From: Planning.North <Planning.North@sepa.org.uk>
Sent: 15 June 2022 10:01
To: Nick Sage; info@fluidec.com
Cc: Mark.Ashton@gov.scot
Subject: RE: 220614 - Tom Na Clach Further Info

ELECTRICITY ACT 1989 SECTION 36 AND SCHEDULE 8: APPLICATION FOR THE PROPOSED TOM NA CLACH WIND FARM EXTENSION IN THE PLANNING AUTHORITY AREA OF THE HIGHLAND COUNCIL.

Figure 13.6c: Hydrological Features (Aerial Image)

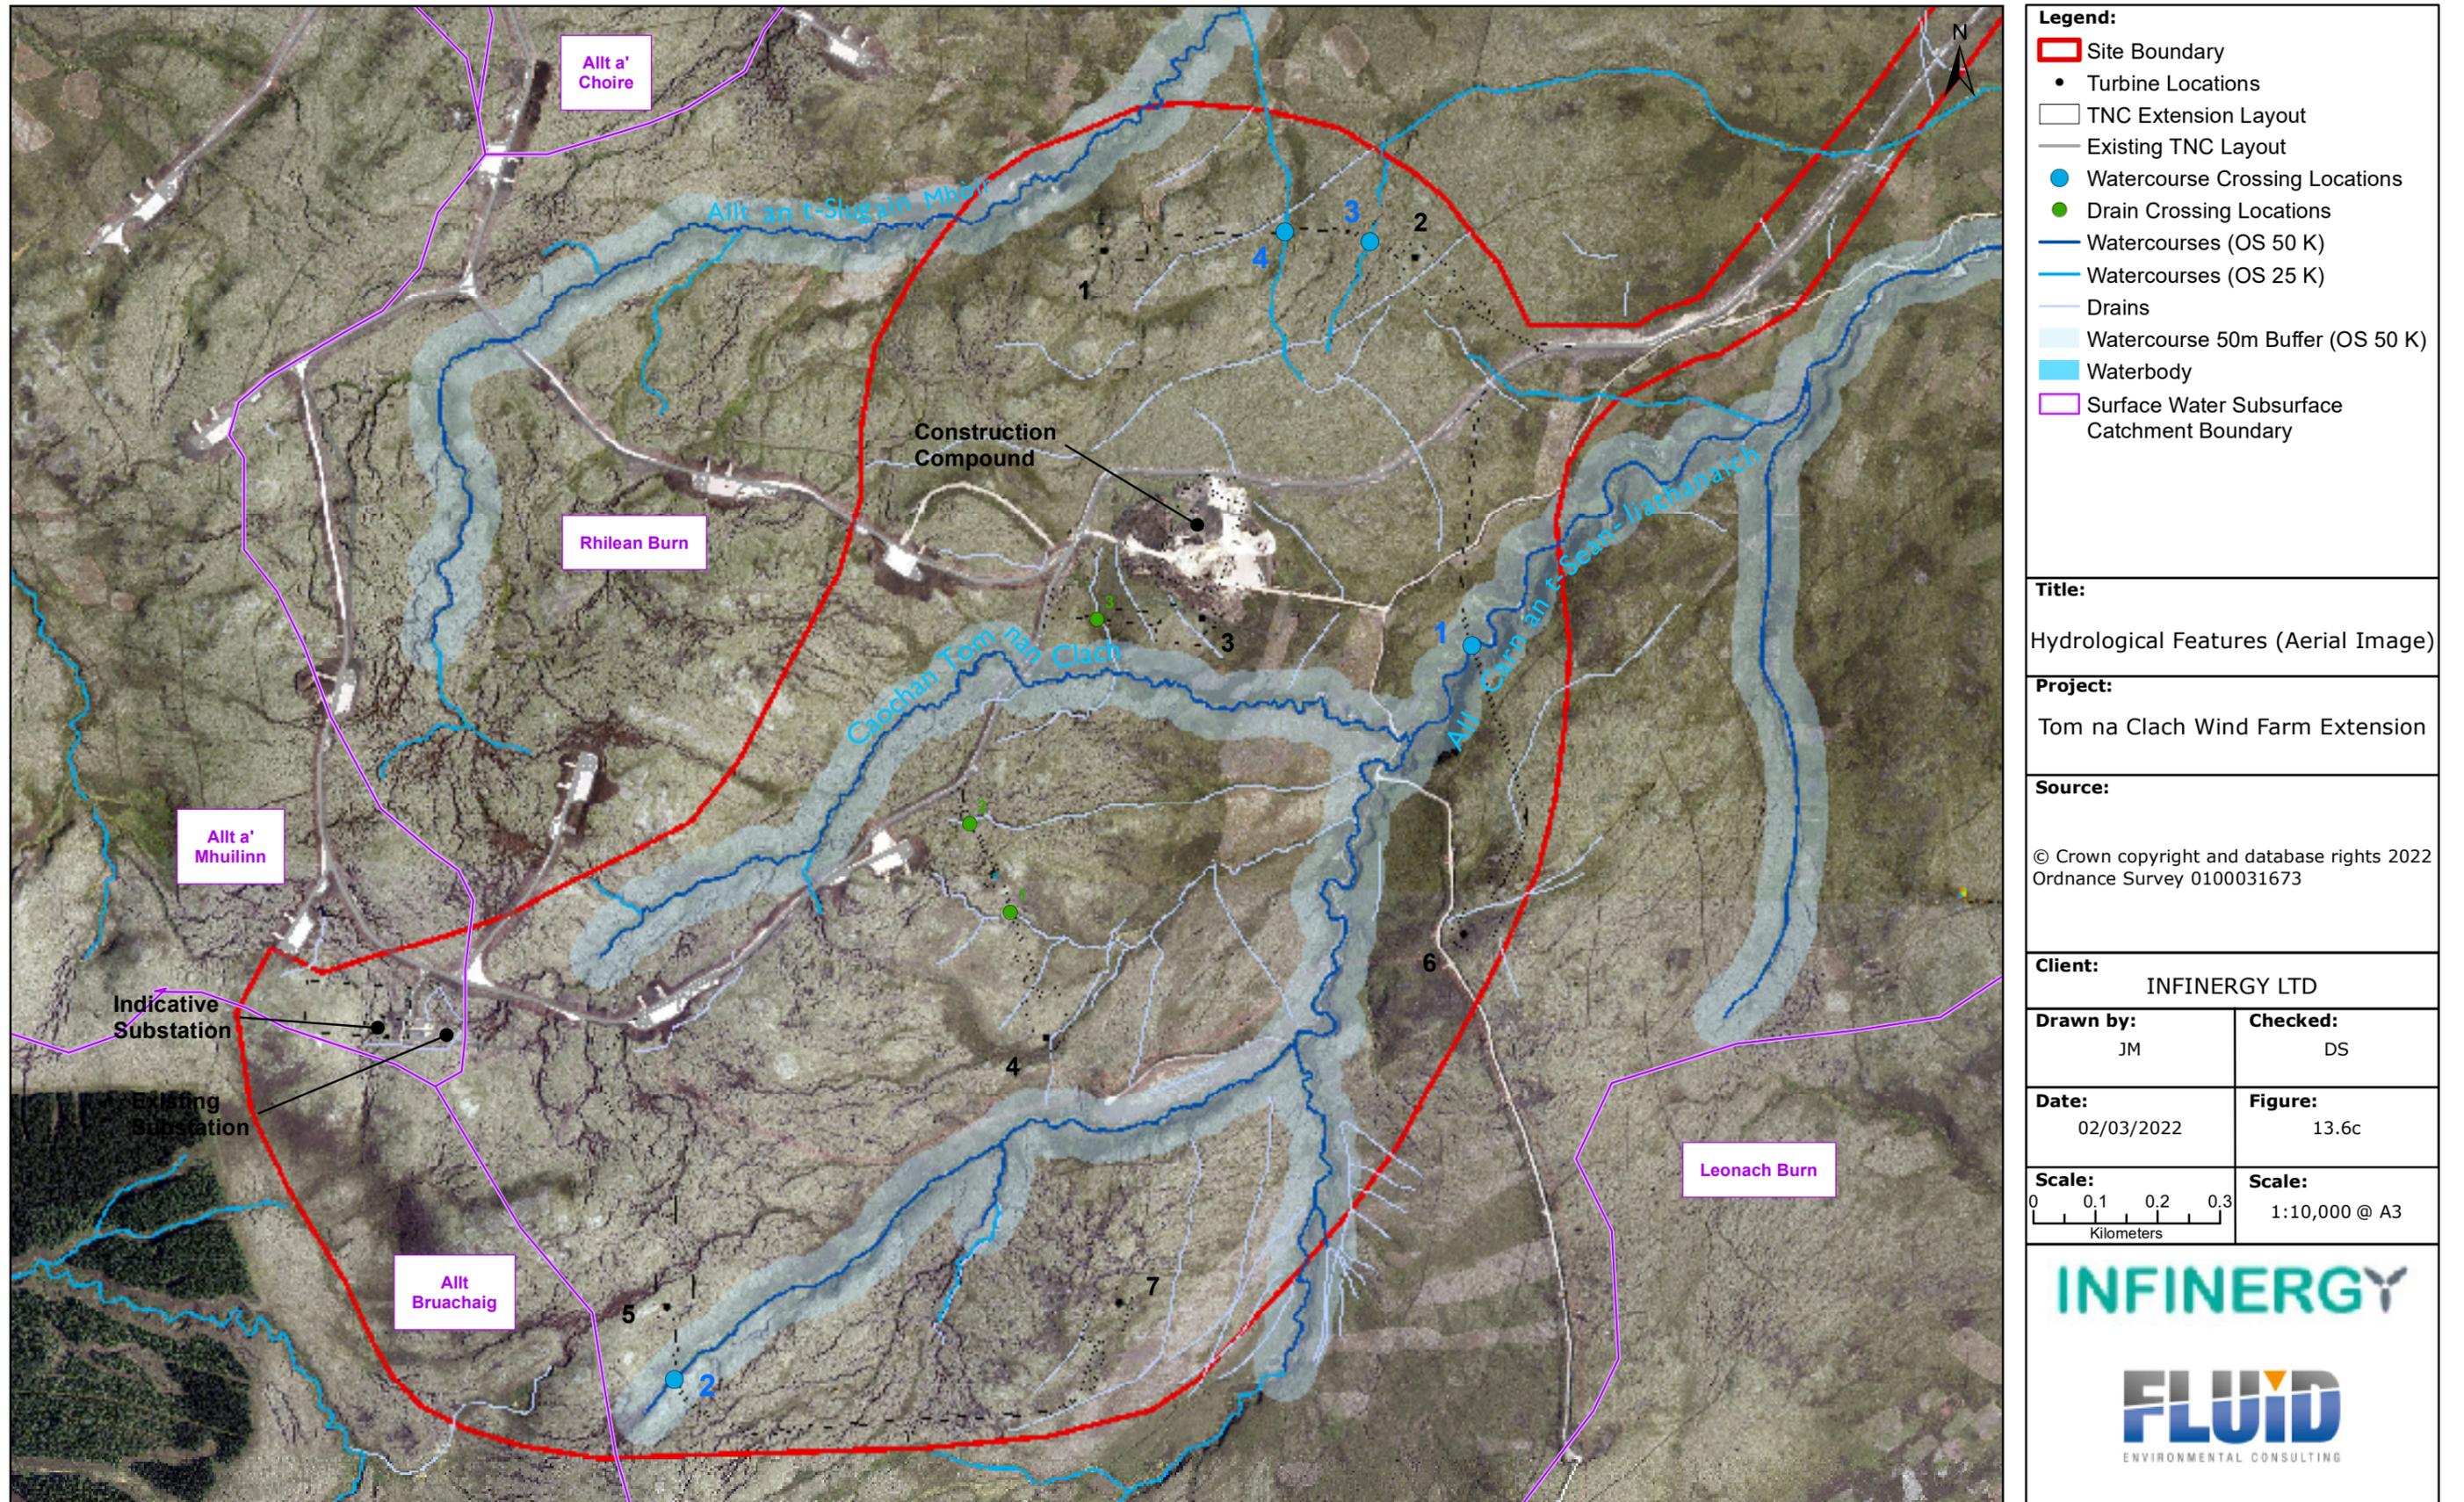
Thanks for the attached response, which is very helpful. I completely appreciate that lots of time and effort has been put into formulating the currently layout and my queries and questions in no way dismiss that. The plates you have provided showing the layout over the high quality aerial photograph basemap is especially helpful. Would it be possible for you to share a version of it for the whole scheme with me – or direct me to it if it already forms part of the submission?

As examples of the types of issues I'm considering just now then (1) Plate 2 in the new submission shows the construction compound making use of existing disturbed areas, which is great. However there is a turbine directly below it which is being accessed from the west by a new track, when the whole area to the north of it is already disturbed ground, and (2) Plate 6 shows the location of T6 directly adjacent to an existing track – yet it has its own new track.

We're somewhat struggling with this one I'm afraid. Its not clear that the infrastructure layout fully minimises peat disturbance and much of it is located on small watercourses or drainage grips and I've yet to find any sort of clarification as to which are natural features (which should be avoided) and

which are man made structures (which could be either moved or filled in as part of peatland habitat restoration). Nick, can you shed any light on this latter issue?
